Kiwi Property PPC: Drury Central

Landscape and Visual Effects s92 Request Response

Review by Rebecca Skidmore dated 4 March 2020

Figure 13: Overlay 20m Hingaia Stream corridor with zones and transmission line corridor.

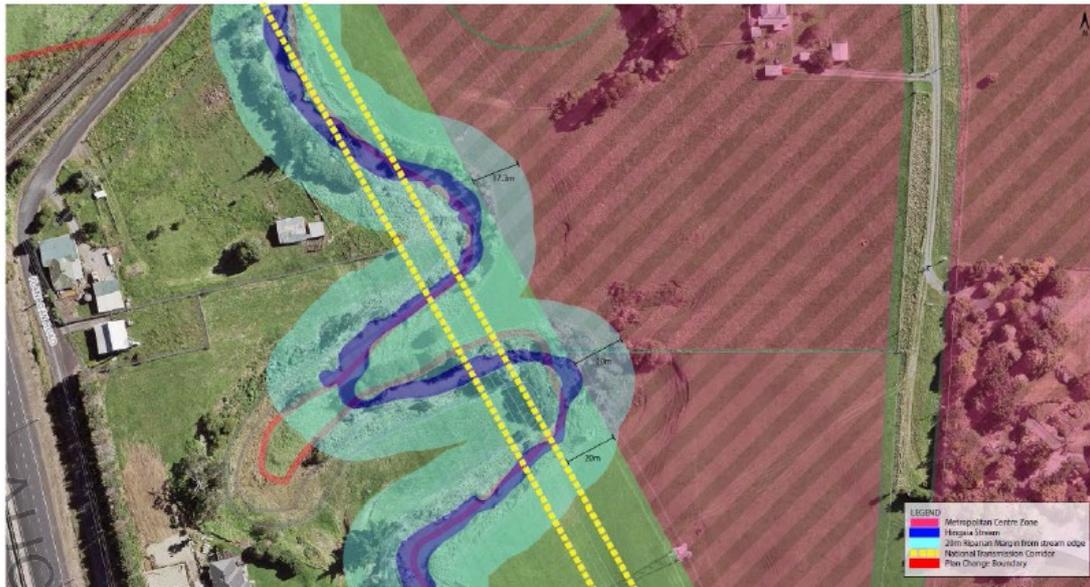
3. The provisions relating to the creation of an esplanade reserve along the Hingaia Stream are set out on p.17 of the LVEA report. Figure 13 shows the relationship between the transmission line corridor and the stream alignment. Please provide an analysis of the influence of the transmission line corridor on the future character and amenity of this open space corridor and advise whether there are any plans for realignment of this corridor.

4. Please provide comment on the appropriateness of the boundary between the Business – Metropolitan Centre zone and the Open Space – Informal Recreation zone from a landscape perspective.

There are no plans for the re-alignment, repositioning or replacement of the lattice tower pylons with monopoles along this corridor. These are the main Transpower high voltage transmission lines providing electricity to Auckland.

The transmission lines to an extent detract from the amenity and visual attractiveness of the landscape experience within this open space corridor. However, in reality their impact is only moderately adverse where a pylon disrupts the view with minimal effect in locations where the transmission lines overhang the open space.

As illustrated in Figure 13 of the LVEA - copied below - the proposed boundary of the Metropolitan Centre is generated by a linear offset from the transmission lines which is what creates the 'straight line' boundary.

The Hingaia Stream meanders under the linear transmission line corridor, it is fully anticipated that at the time of resource consent an appropriate balance between the creation of a desirable, publicly accessible, high quality recreational open space esplanade reserve adjoining the Town Centre and the interface of built development, including a public street to define the edge of the reserve will be agreed between Council, including Council’s Parks personnel, and the developer.
